ASSESSMENT REPORT

Werris Creek Coal Mine Modification

Emplacement Area, Dry Separation Plant & Void Water Irrigation (10_0059 MOD 2)

Figure 5: Proposed Final Landform

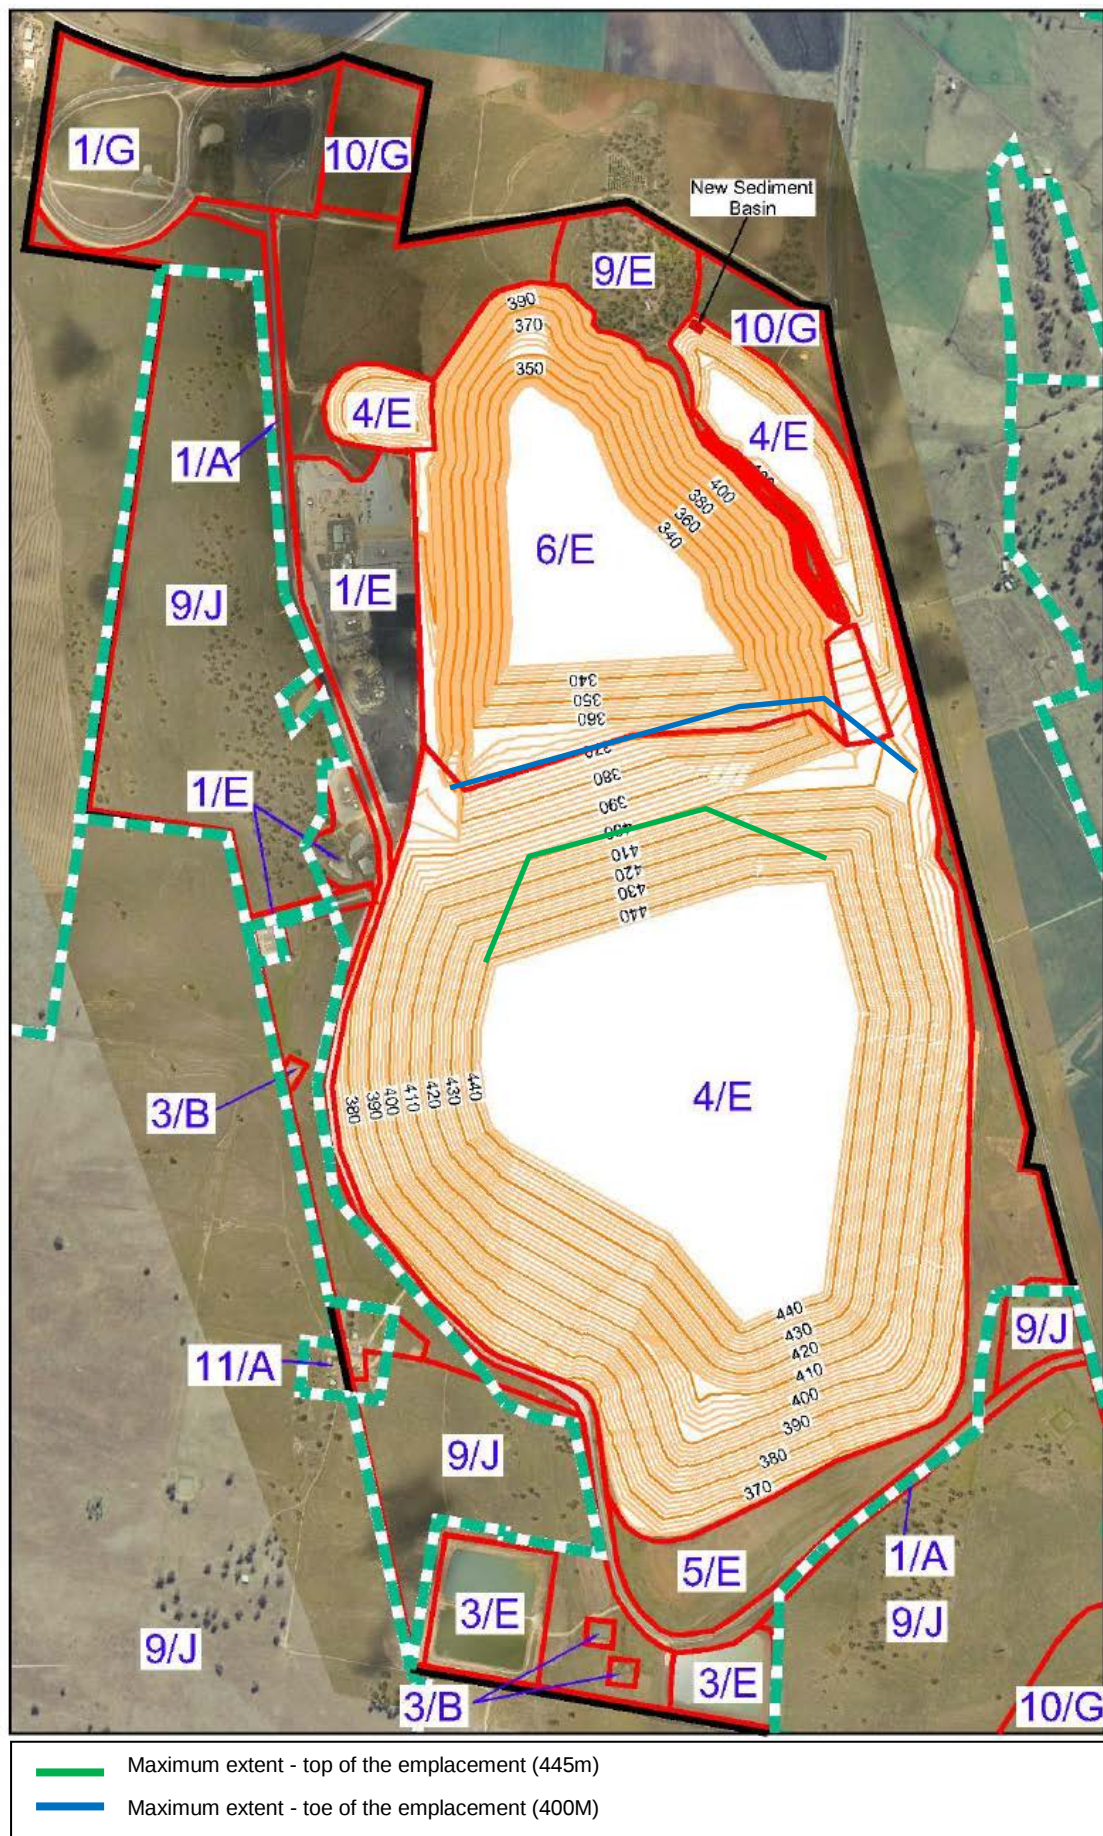
The proposed final landform would not be substantially different to that approved, and therefore, the proposed modification would be unlikely to result in any significant long term visual impacts. Notwithstanding, DRE raised concerns that the final landform would not be sympathetic to the surrounding topography. However, DRE also acknowledged that the emplacement area is constrained by a number of factors, including the footprint and height of the emplacement area, and recommended that the final landform design be improved through the development of the Mining Operations Plan following any approval.

In assessing this issue, the Department notes that WCC considered alternative options in the development of the proposal including measures to reduce the plateau and to create a more distinct 'hill top'. WCC concluded that the height of the Overburden Emplacement Area would need to be increased by at least 10 m in order to accommodate this design, and that it would have very little benefit for the majority of residential receivers in regard to visual impacts.

Notwithstanding, the Department believes that WCC ought to minimise the visual impacts and construct landforms sympathetic to natural landforms (including landform micro relief) as far as practicable. The Department has recommended a condition in this regard which is consistent with current best practice for mining projects in NSW.

WCC would also be required to update the Rehabilitation Management Plan, to the satisfaction of DRE, and reflect any changes resulting from the proposed modification. With these measures in place, the Department is satisfied that the proposed modification would not result in any significant visual impacts.

Figure 6: Predicted Worst Case Noise Levels

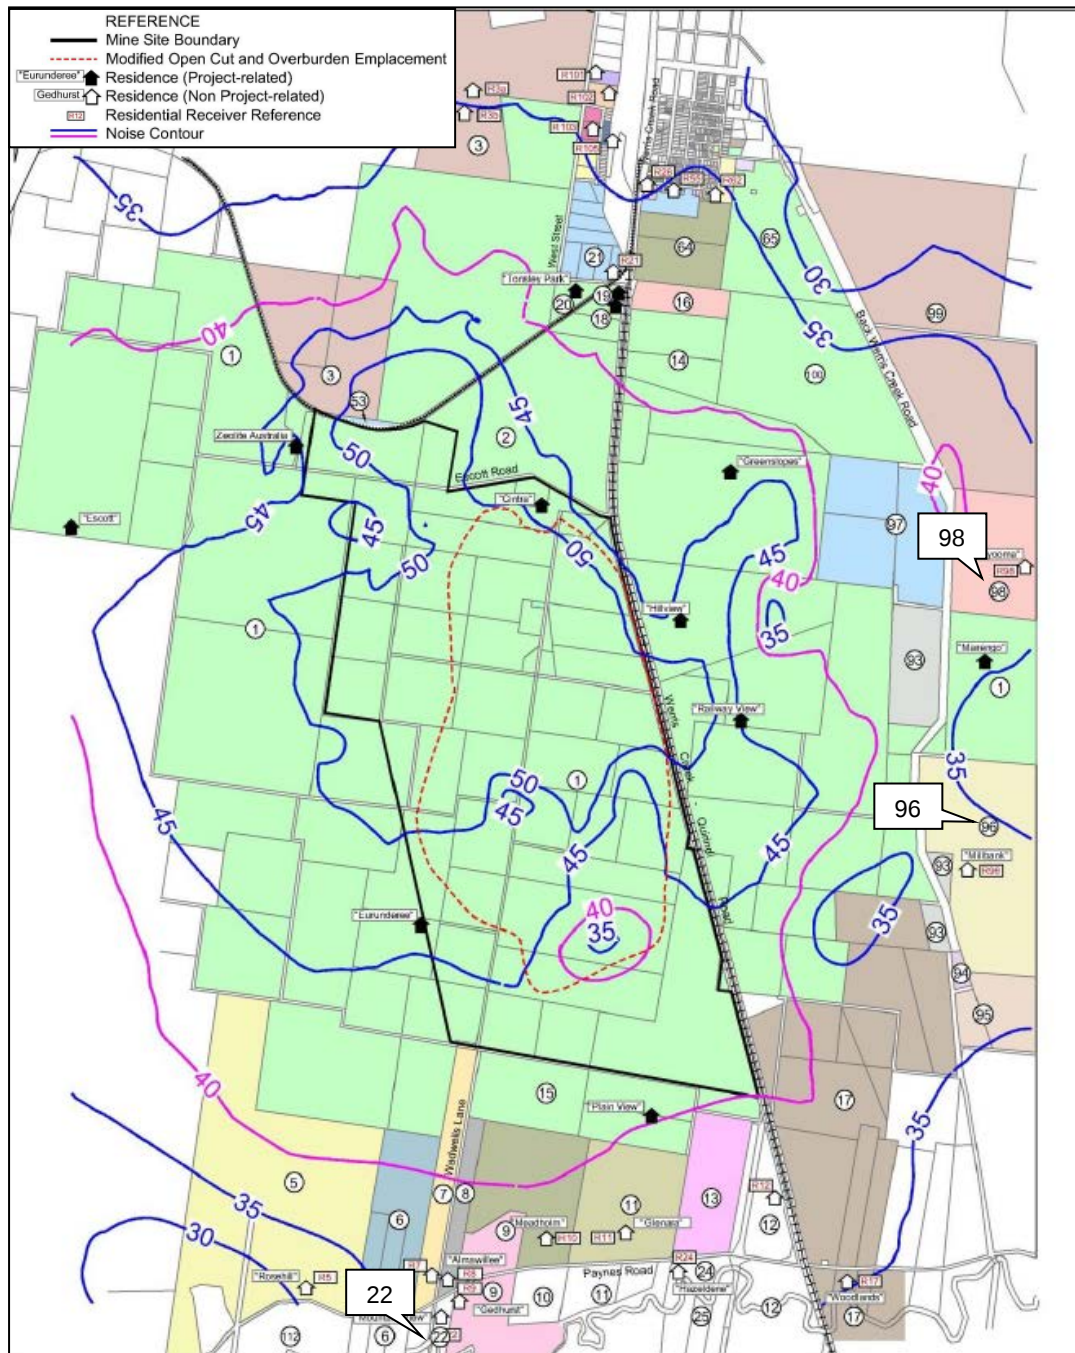
The assessment predicts operational noise levels would increase at 3 privately-owned residences located east and south of the mine (Properties 96, 98 and 22). The worst case noise levels for these residences are shown in Table 1, and the relevant noise contours are shown on Figure 6. The assessment indicates that WCC would be able to continue to comply with relevant criteria at the remaining residences.

The EPA has recommended that the approval be modified to be consistent with the noise agreements for these properties. The Department does not consider that this is warranted given that the project approval clearly states that the noise limits do not apply when agreements are in place. The Department is satisfied that noise impacts can be appropriately managed by the existing agreements, and has therefore recommended that the criteria be amended to reflect the worst case noise predictions for receivers 22 and 98 (37 dB(A) and 38 dB(A) respectively).

Noise levels at the remaining affected receiver (Property 96) would increase by 1 dB(A) (i.e. up to 38 dB(A)). In considering this issue, the Department notes that 1 dB(A) increase would be unlikely to result in any discernible change to the noise levels at the receiver. The Department is also satisfied that WCC is implementing all reasonable and feasible measures and has considered all reasonable alternatives to reduce noise impacts from the mine and the proposed modification.

Additionally, the Department notes that this residence already has mitigation rights under the approval, which is consistent with the NSW Government's *Voluntary Land Acquisition and Mitigation Policy*. Accordingly, the Department considers that any minor additional impacts resulting from the proposal can be appropriately managed under the existing conditions. Based on the above, the Department has recommended that noise criteria for receiver 96 be modified to reflect the worst case noise prediction from the modification (i.e. 38dBA).

Figure 7: Indicative Location of Void Water Irrigation

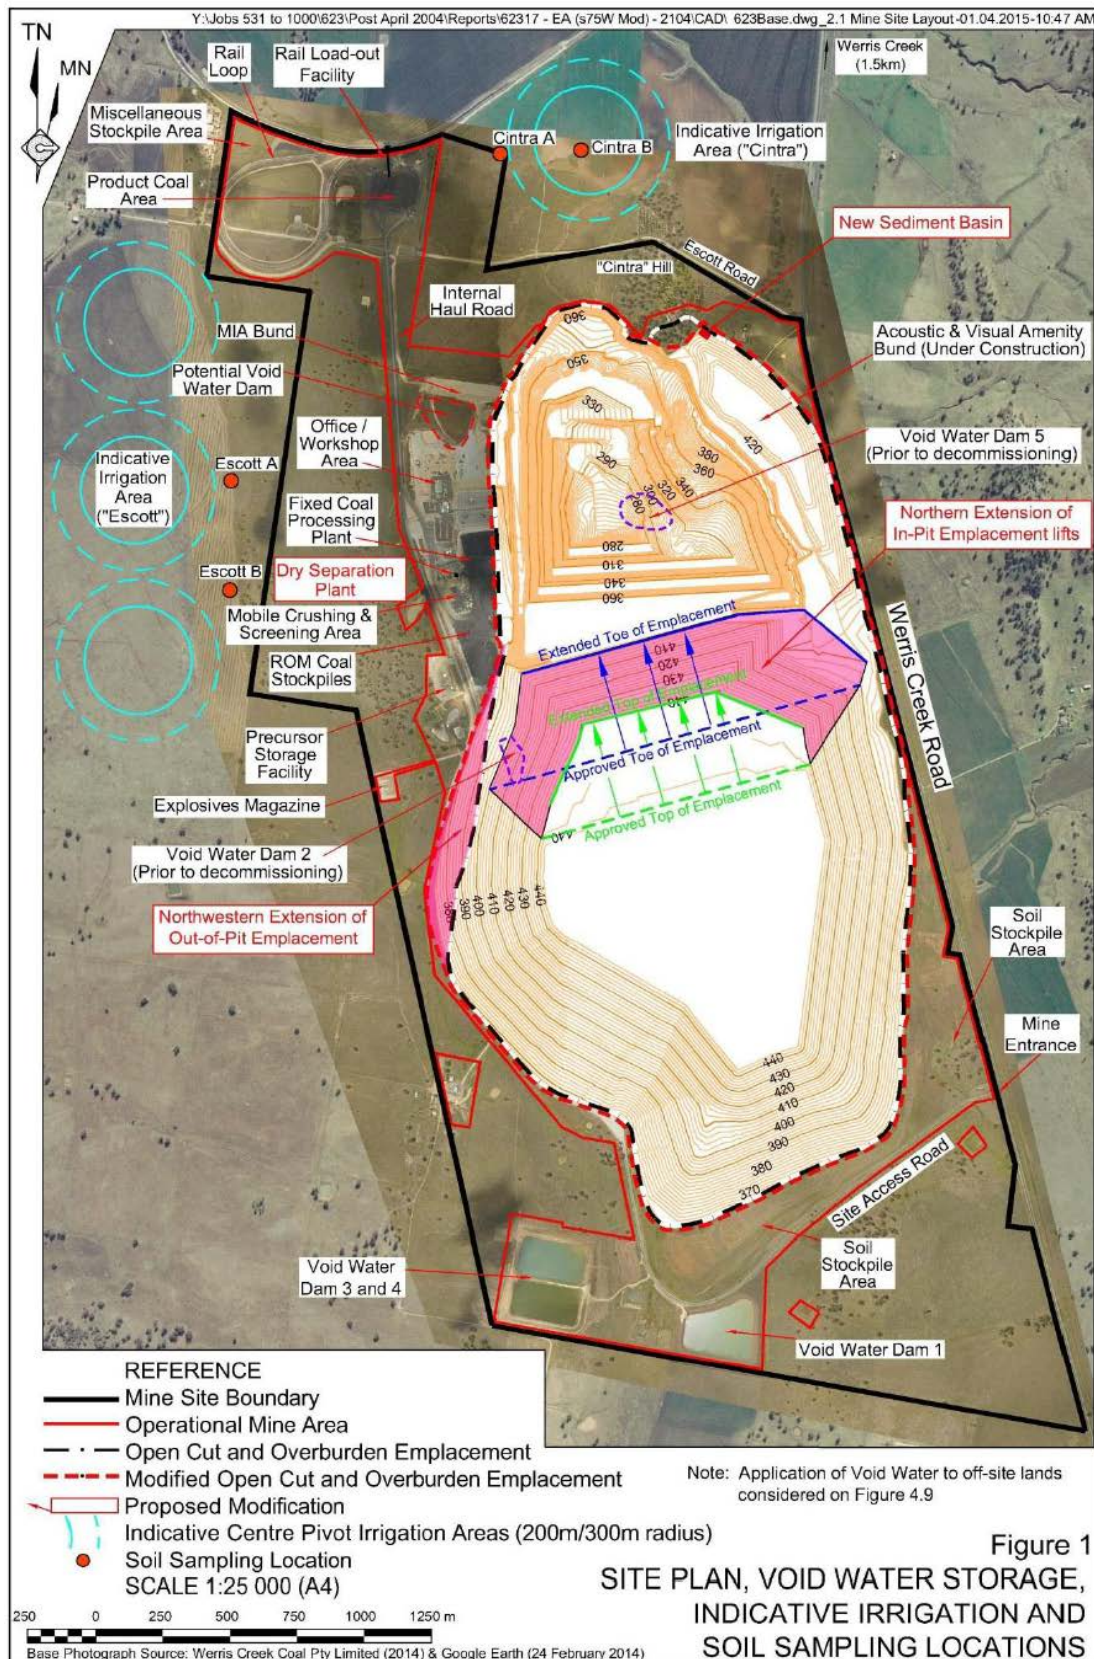
The Department notes that the assessment only provides an indication of the likely impacts of the proposal, and that further site specific details would be required following any approval. To this end, WCC has committed to undertaking detailed soil sampling once contractual arrangements are in place with relevant land/lease holders.

However, the EPA raised concerns about the risk for uncontrolled discharges from the site, if WCC are unable to dispose of enough water using irrigation. In these circumstances, the Department notes that WCC would be required to store any excess water in the pit, and there is therefore no significant risk of any uncontrolled discharges from the site.

The Department has recommended that the suitability of each site designated for water application be considered under an Irrigation Management Plan. As part of this plan, WCC would be required to:

- describe the methodology for the transfer and application of void water for each site;
- undertake site specific soil analysis and consider the short and long term impacts of salinity and sodicity on soils;
- identify parameters for the sustainable application of void water to maximise uptake and minimise percolation and/or run-off;
- identify the appropriate approvals held under the *Water Management Act 2000*;
- implement a program to monitor soil characteristics and void water quality; and
- describe the procedures to be implemented to measure and report on the quantity of water supplied to each individual user.

WCC would be required to consult with both DPI Water and EPA in the preparation of the Irrigation Management Plan, and prior to transferring any void water from the site. With these recommendations in place, the Department is satisfied that the irrigation of void water would be suitably managed.
